Architectural Review  
and Historic Preservation Board  
Agenda Report

Meeting Date 01/16/2019

File: AR 18-17

RE: Architectural Review 18-17 (Pabbi Nord Apartments)  
824 Nord Avenue, 043-220-019

**3 Stair East - Bldg Two**  
3/32" = 1'-0"

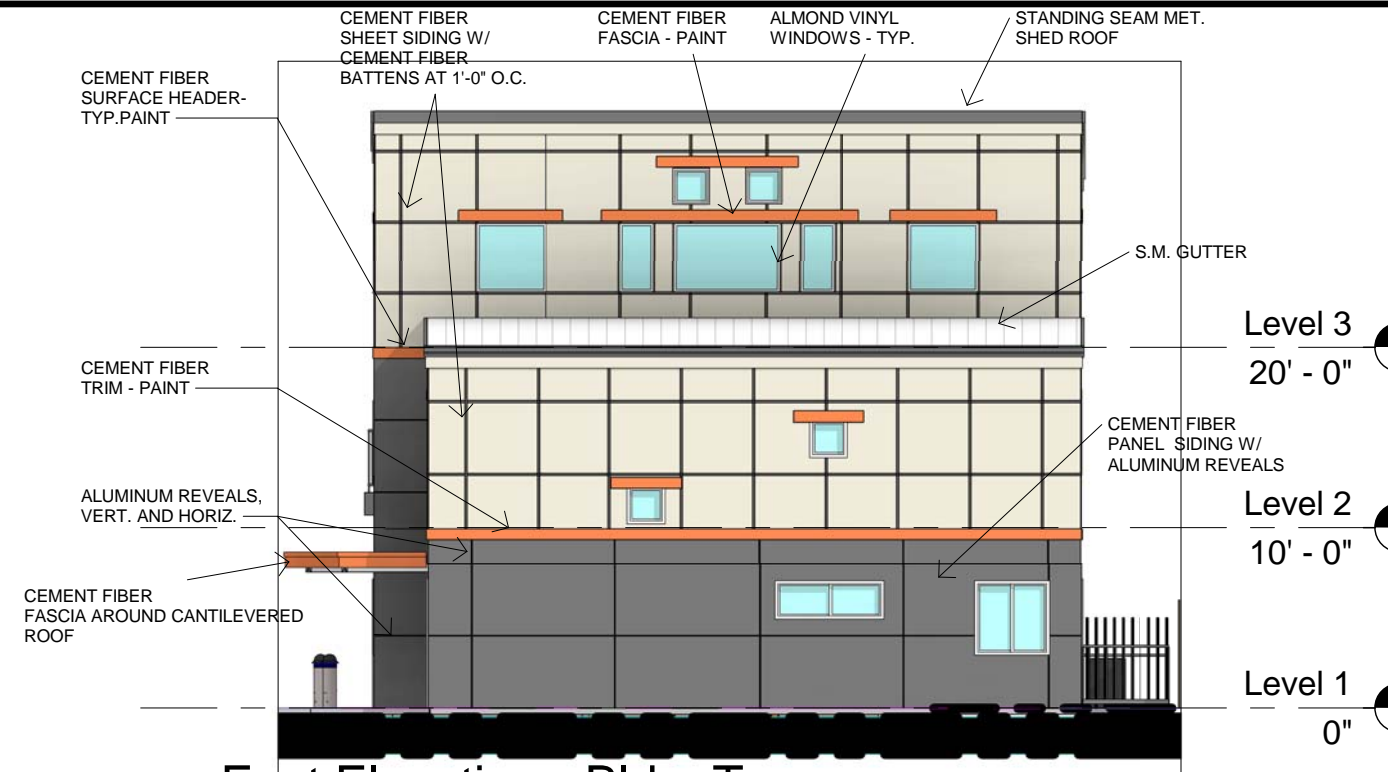
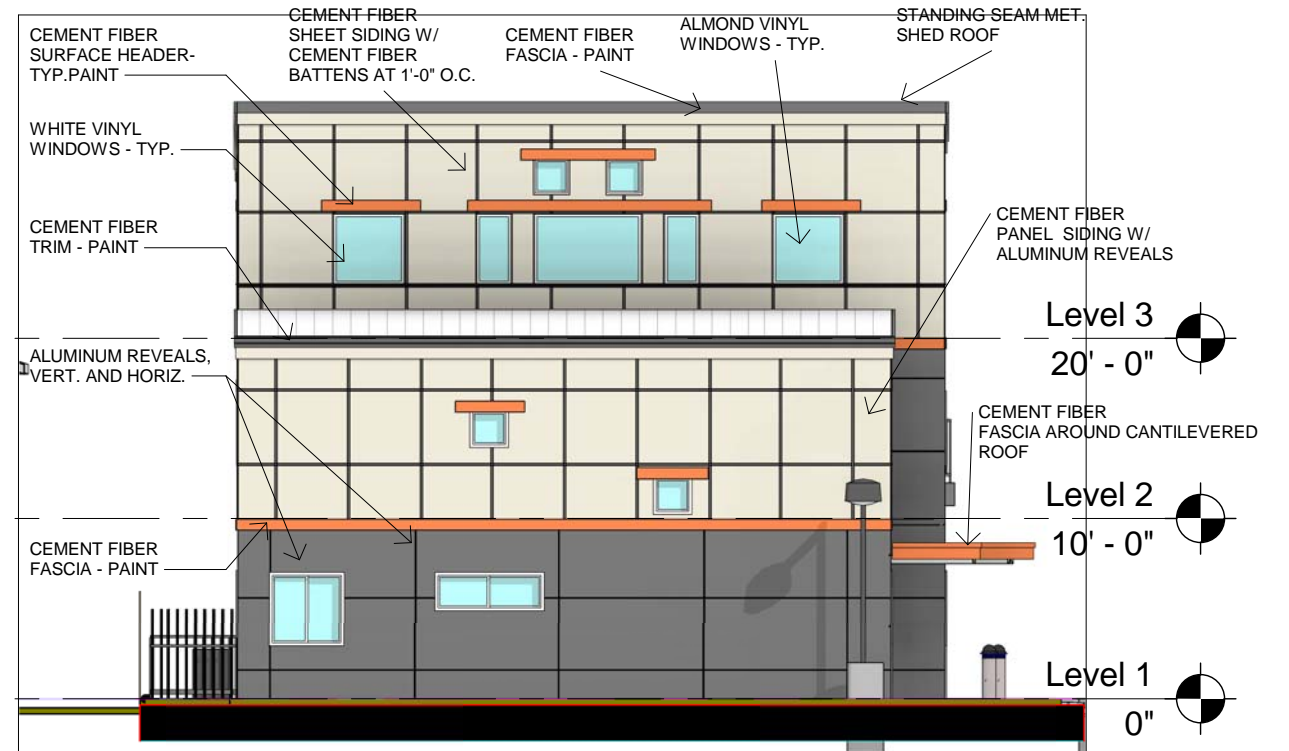
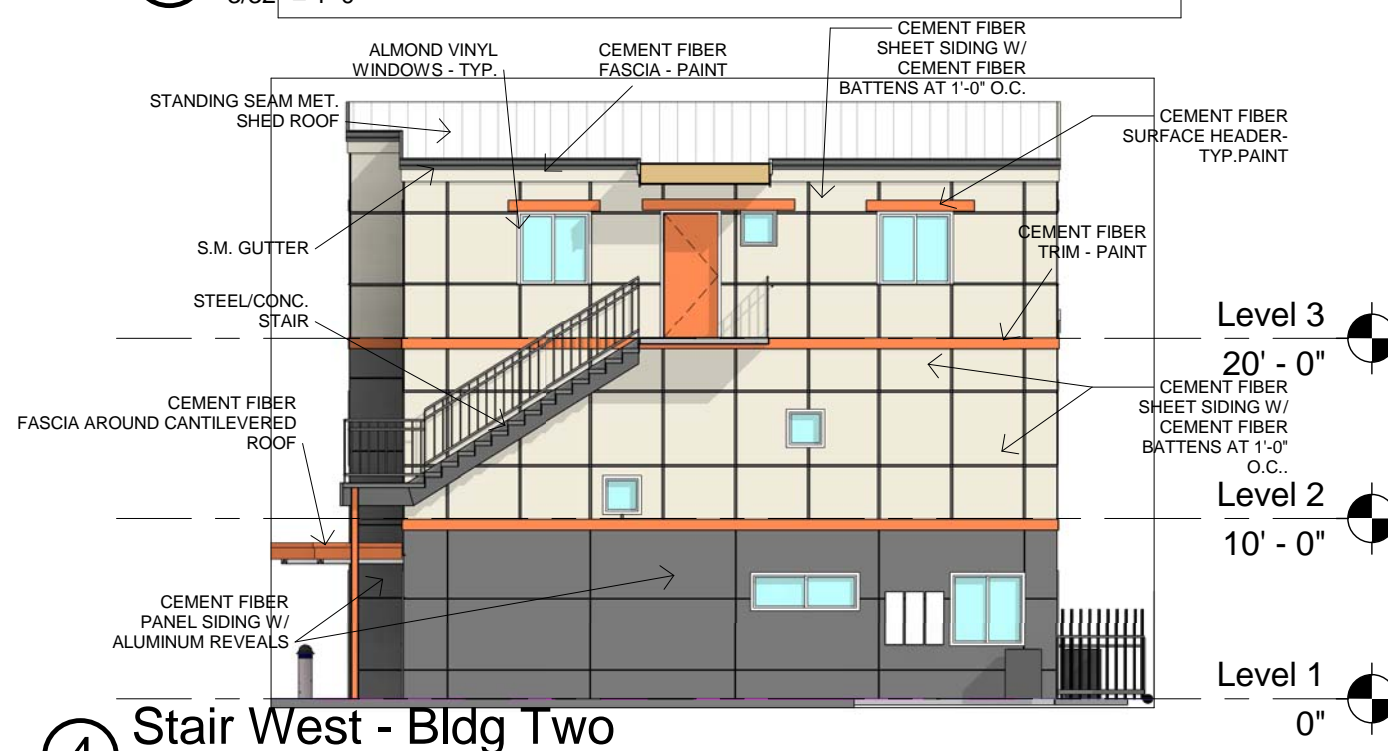
2. ***Explore alternative color scheme.***

3. ***Explore a possible redesign of the building's roof forms.***

**Response:** The applicant has opted to use the proposed orange color for doors, awnings and trim elements. The building's main body would be beige and gray (see **Attachment C**, Updated Color Elevations and **Attachment D**, Updated Color Board). Second and third story exterior finishes that previously gave a "shipping container" appearance have been modified to a sheet siding cement fiber panel, giving the building's a uniform appearance.

**Response:** The applicant has indicated that this sloping, “butterfly” roof form was selected because of the ductless HVAC system used for the building. The sloped roof allows for the elimination of wasted attic space that would come with a gable roof (see **Attachment E**, Aerial View of Roof). Similar roof-forms can be found along the Nord Avenue corridor, such as Brentwood Apartments and Campus Walk Apartments.
